## Product Change Notification - SYST-16MXTC292

ERRATA - dsPIC33CK256MP508 Family Silicon Errata and Data Sheet Clarification Errata Document Revision

## dsPIC33CK256MP508 Family Silicon Errata and Data Sheet Clarification

FIGURE 1-1: I/O RAMP

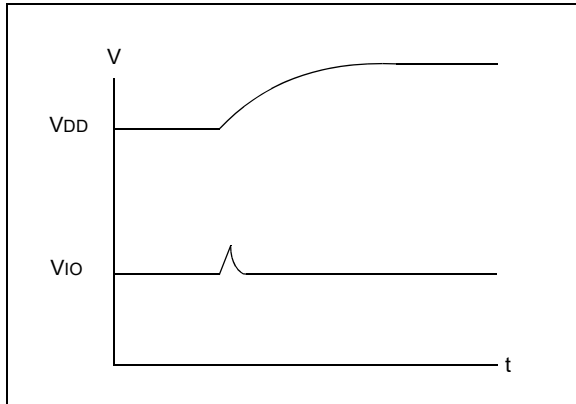
During a fast device power-up when the VDD ramp is less than 4 mS, the I/O pins may drive up to 100  $\mu$ A current for a duration of up to 10  $\mu$ S (Figure 1-1).

1. Slow down the VDD ramp time (greater than 4 mS for VDD to ramp 0V to 3.3V).
2. Ensure the circuitry that is connected to the pins can endure this pulse.

Example applications affected may include complementary power switches, where a transient current shoot-through might occur. High-voltage applications with complementary switches should power the high-voltage 200  $\mu$ Sec later than powering the dsPIC<sup>®</sup> device to avoid the current shoot-through. This behavior is specific to each device and not affected by aging.
